River District Design Commission

APRIL 9, 2020

AGENDA

SHEET NAME
NORTH-WEST AND SOUTH-EAST ELEVATIONS

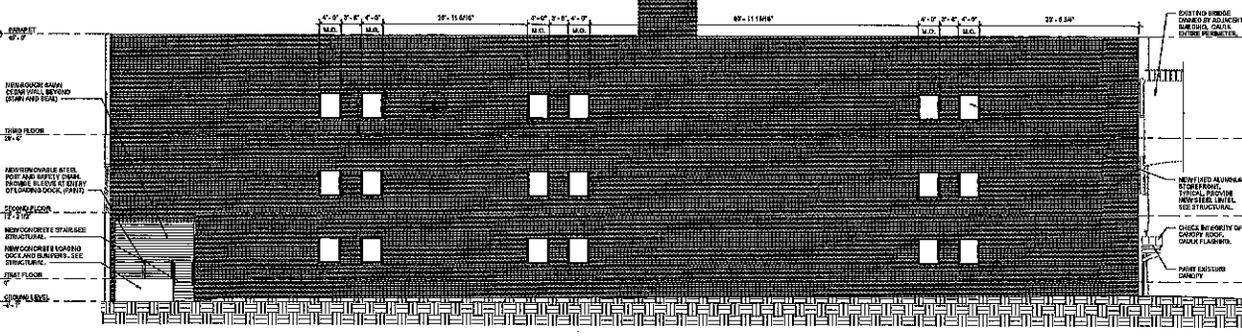
A total of 18 (six per floor) new 4'-0 x 4'-10 ½" aluminum storefront windows will be placed along the South-East façade of the building, facing the adjacent parking lot. No windows are currently in this façade. On the North-West façade, facing Wilson Street, the existing corrugated metal wall will be removed, revealing the existing covered alleyway. In the opening, a new concrete stair and deck will be located with a wheelchair lift for accessible pedestrian entry into the building. A new rough-sawn wood-clad wall will divide the new entry from the new concrete loading dock on the South-East side, and block the loading dock from the view of the street. Also along the North-West Façade, the two existing roll-up doors will be removed and the existing openings will be infilled with aluminum storefront. The mullion pattern will match the existing roll-up doors. DHR/NPS have approved all of these modifications.

Staff recommends approval of this work. It is consistent with the guidelines, and has received approval from DHR/NPS.

SHEET NAME
EXTERIOR ELEVATIONS

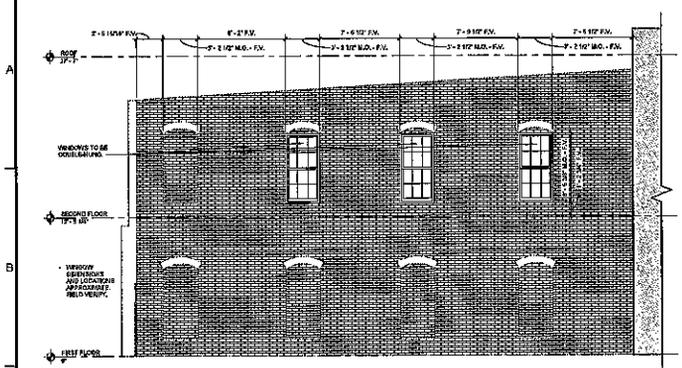
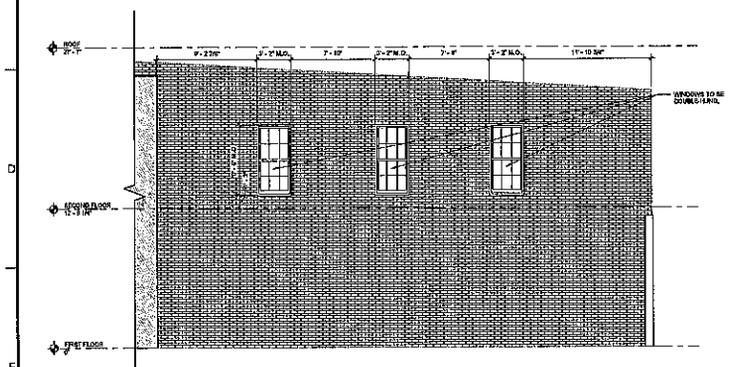
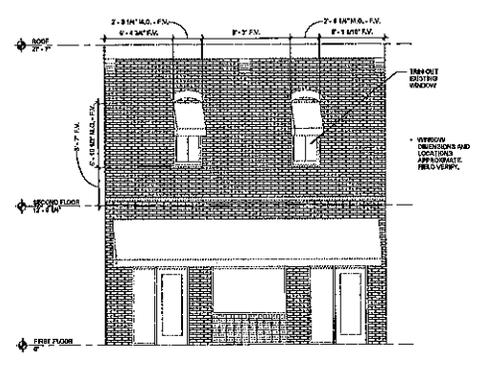
Request a Certificate of Appropriateness at 122 S. Market Street to open previous windows currently bricked in. Install new windows of Aluminum or Fiberglass.

Since these areas are bricked, staff has no recommendation on the type of windows as this will be a new feature.

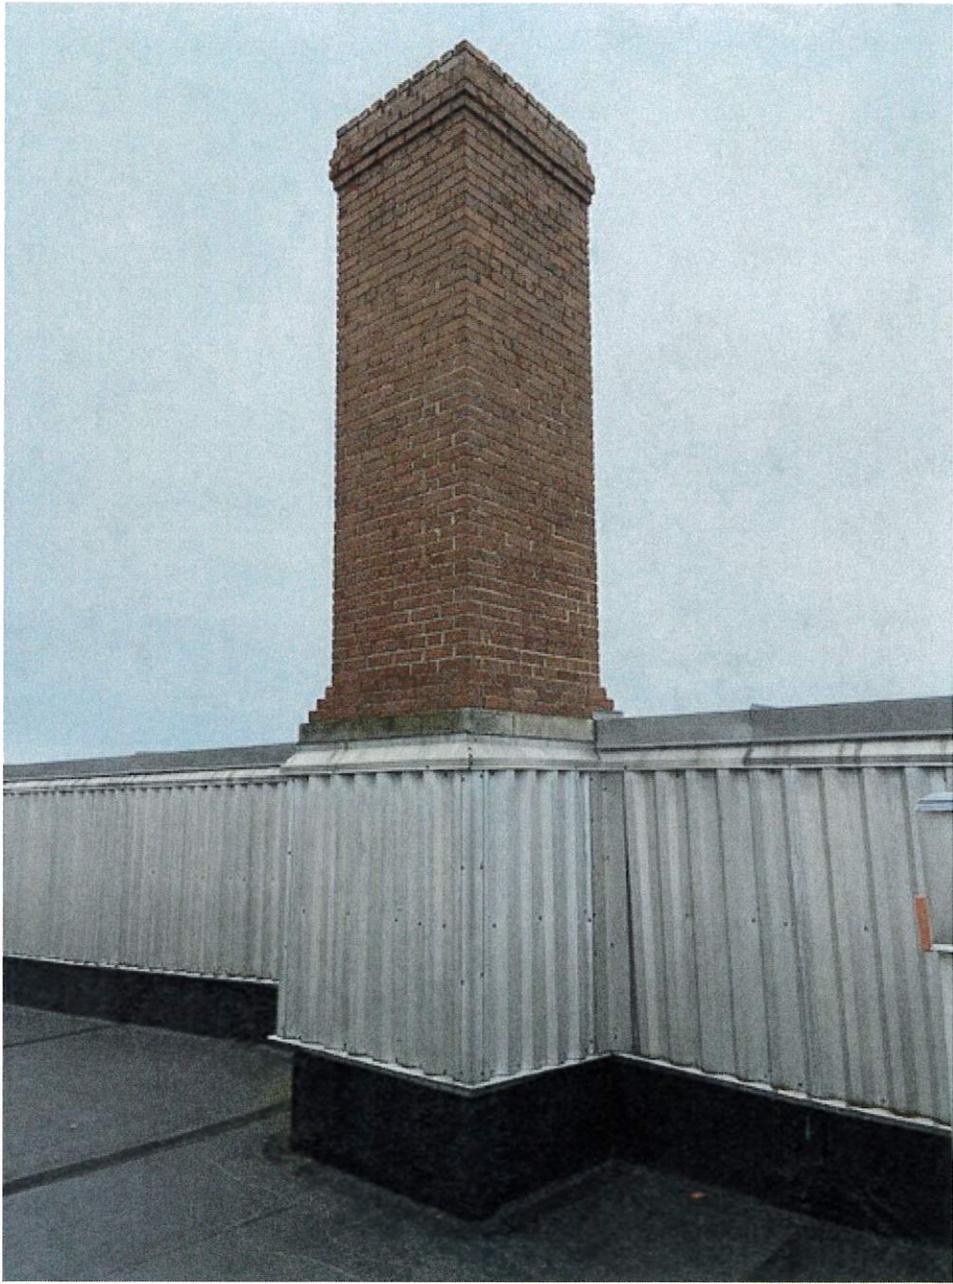
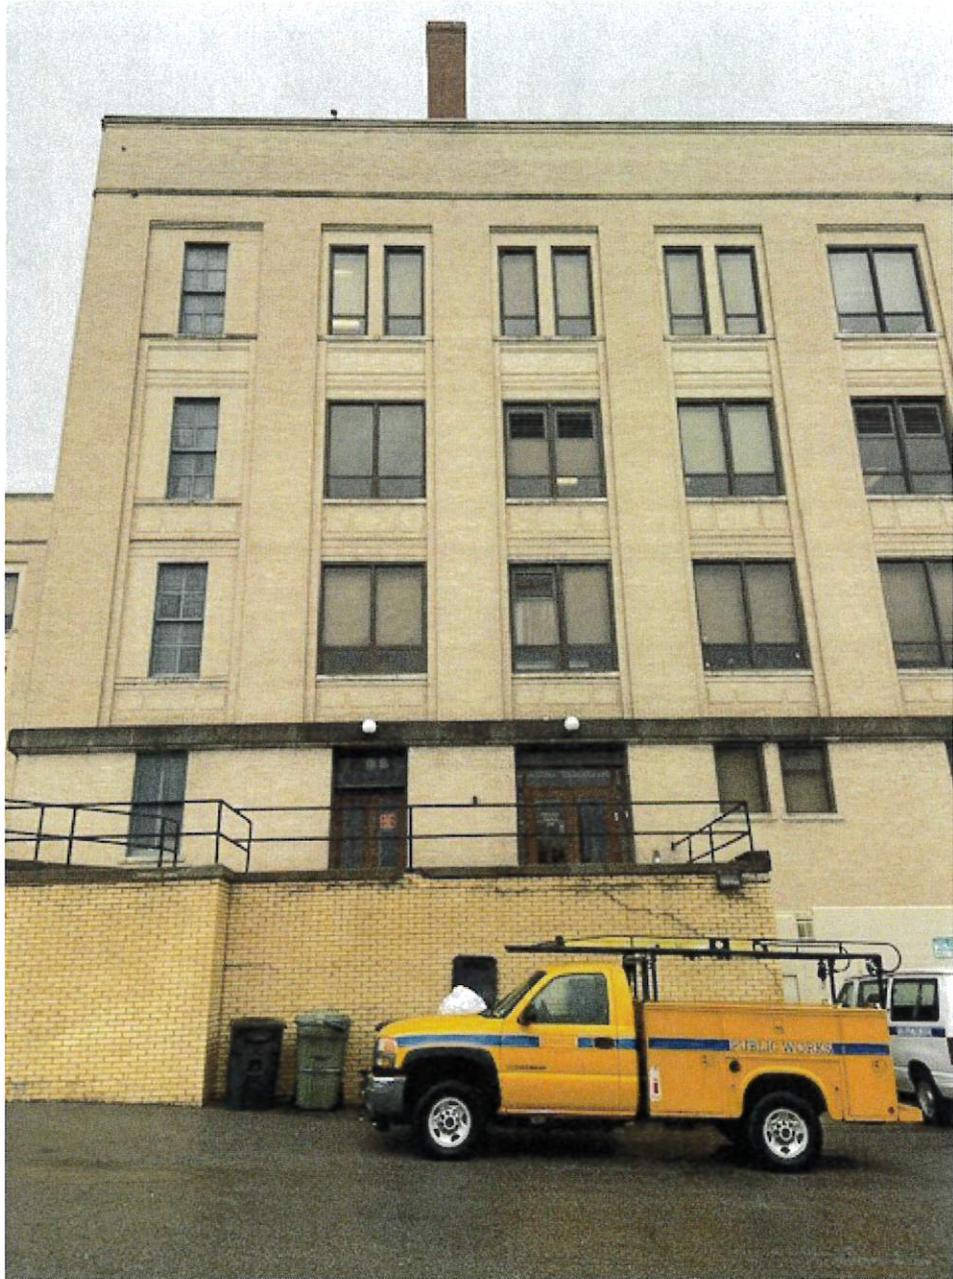
Request a Certificate of Appropriateness at 427 Patton Street to remove the brick portion of the chimney (Which is no longer in use) to the top of the parapet wall and cap the opening. Removal of the abandoned chimney will remove the safety issue of deteriorated brick pieces falling onto the roof and walking/driving surface and prevent water from continuing to enter the building.

This chimney is no longer functional, and has not been for a number of years. The chimney is structurally deficient and its removal will not substantially change the appearance of City Hall.
